**HISTORIC LANDMARK COMMISSION**  
**APPLICATION FOR A CERTIFICATE OF APPROPRIATENESS**  
**JANUARY 11, 2023**  
**HR- 2022-155777**  
**WEBSTER HOUSE**  
**706 OAKLAND AVENUE**

Alter a circa 1917 single-family residence.

## **COMMITTEE FEEDBACK**

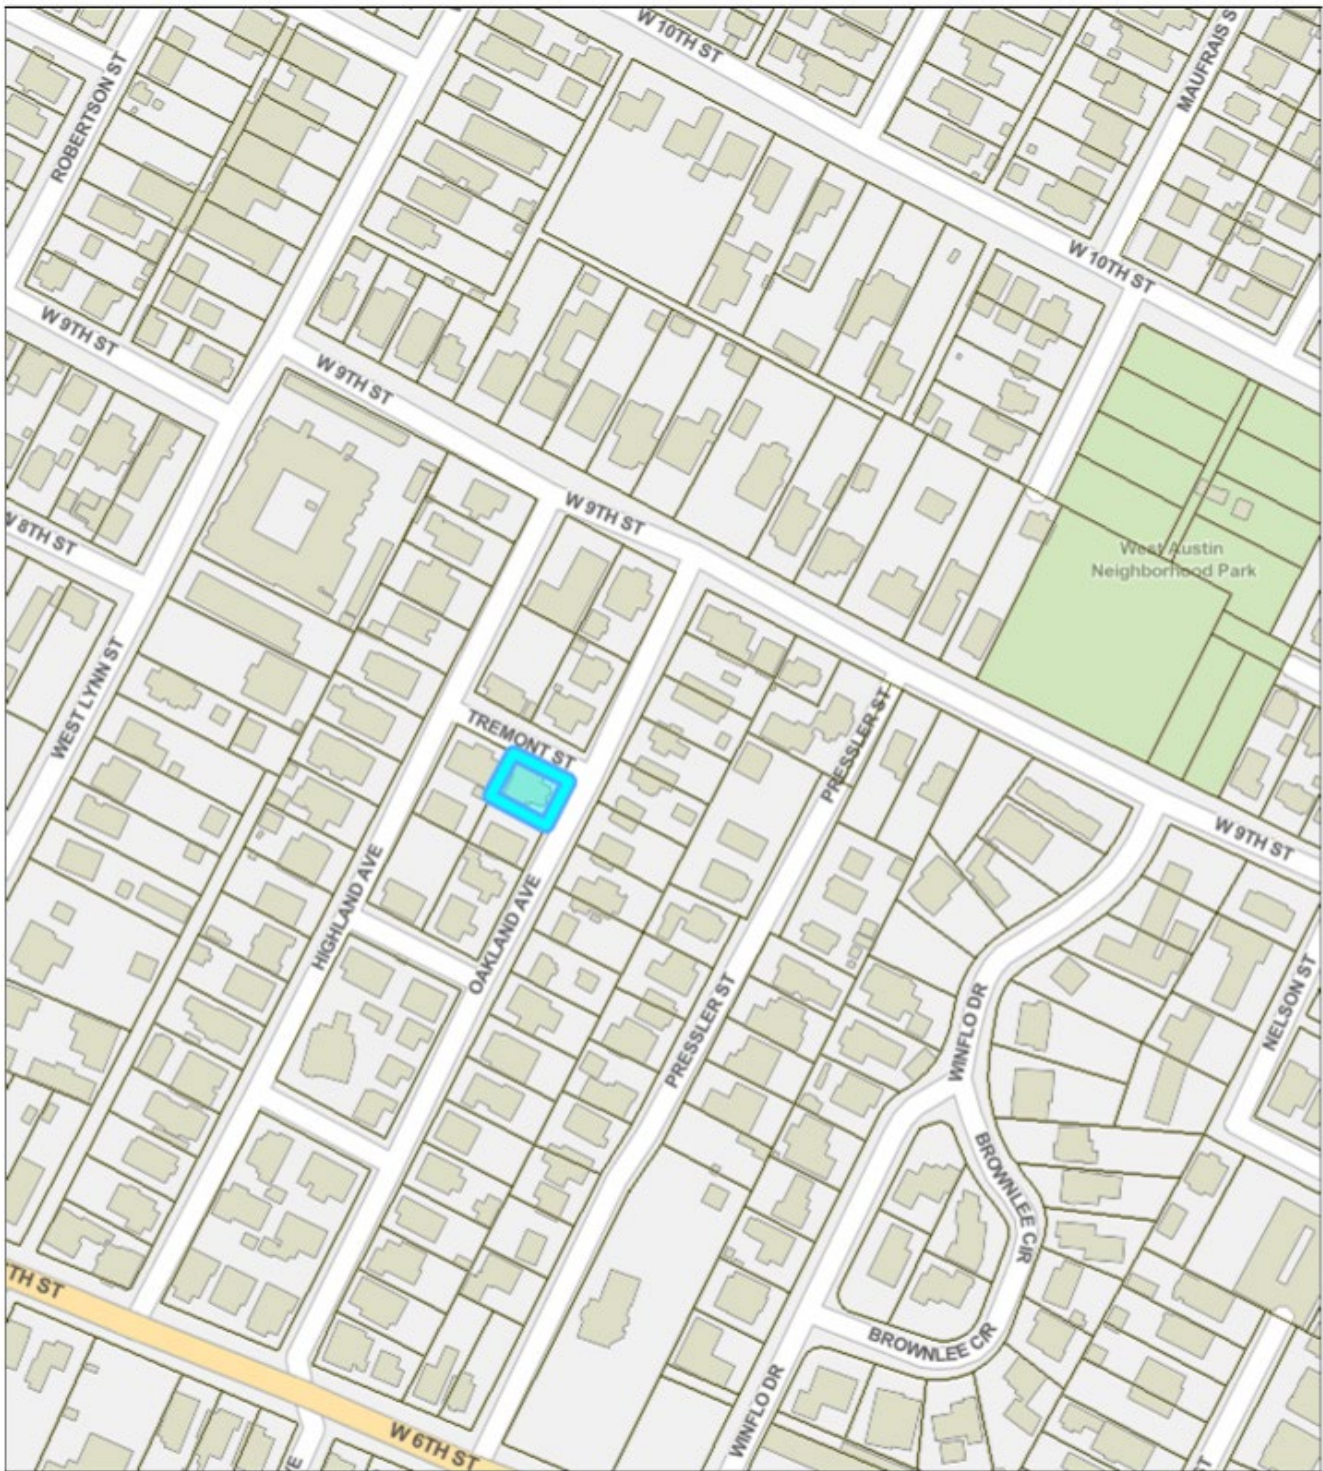
Change metal wall and blend with surrounding exterior materials. Do not duplicate door and window trim. Use partial glazing for new door.

Approve the application. The applicant has changed the proposed new door, window trim, and retaining wall in accordance with Committee feedback.
